Review owner: Emilio Guadarrama. Generated by hardware/tools/gen_station.py
TWO GROUND DOMAINS: GND = bench-referenced, GNDREF = laptop/USB. Never joined.
PRELIMINARY — NOT APPROVED. ARM, FIRE and E-STOP are mechanical, panel-mounted.

Ignitia Rocket Lab	
Sheet: /	
File: talavera-station.kicad_sch	
Title: TALAVERA v1 — Control Station Board	
Size: A1 | Date: 2026-11-06	Rev: A
KiCad 8.0.4	Id: 1/1

1. UMBILICAL — cable B to the bench

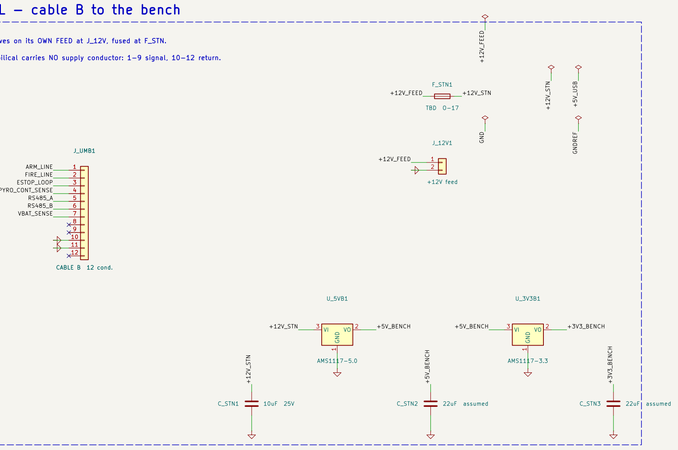
Bench-side rails: 5 V for the 6N137, 3.3 V for the SP3485.
C_STN1–4 added: this board previously had NO rail decoupling at all.
22 uF values are ASSUMED from the AMS1117 stability note — confirm (O-20).

H-2 FIX: the CONTINUITY test button is REMOVED. As drawn it shorted PYRO_CONT_SENSE to ground, which is the lamp-good state, so the test reported a good match whether or not one was connected. A test that cannot fail is worse than no test.

CORRECTION, 9 Nov: the note here previously said sensing is continuous and that current flows through the e-match whenever the bench is powered. THAT IS WRONG and is withdrawn — nothing sources that current. There is NO WORKING CONTINUITY CHECK AT ALL: R_CONT and the opto sit in parallel with the match with no pre-arm source, so the lamp can never light. It fails to the 'no match' reading, the safe direction.

3. INDICATORS & AUDIO

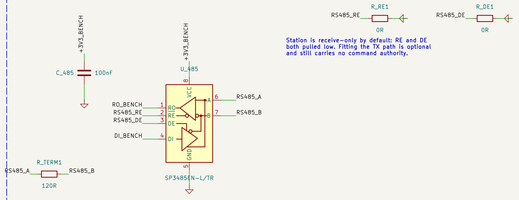
H-1 FIX: the bench opto pulls PYRO_CONT_SENSE LOW when the match conducts, so D_CONT is fed from +12V and sinks into that node.

LAMP LIT = GOOD MATCH. Before this it read exactly inverted.

TBD values await O-2 (load cell) and O-6 (isolator part). ARM / FIRE / E-STOP carry no firmware.

4. TELEMETRY — RS-485 in, isolated, out to USB

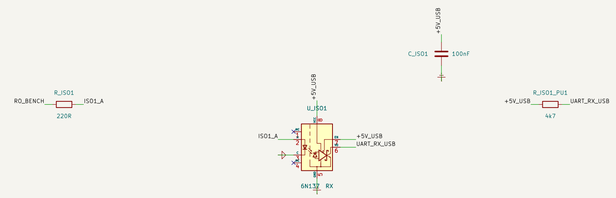
O-21 OPEN, NOT FIXED HERE: this RX path INVERTS. LED conducts on RO HIGH and an enabled 6N137 pulls its output LOW, so an idle mark reaches the CH340C as a continuous break. Telemetry cannot work as drawn. The fix is a part change, not a rewire — see REV-A1-CHANGES.

6N137 is fast enough for 115200 baud. The TLP521 / PC817 already in stock are NOT — do not substitute (O-6).
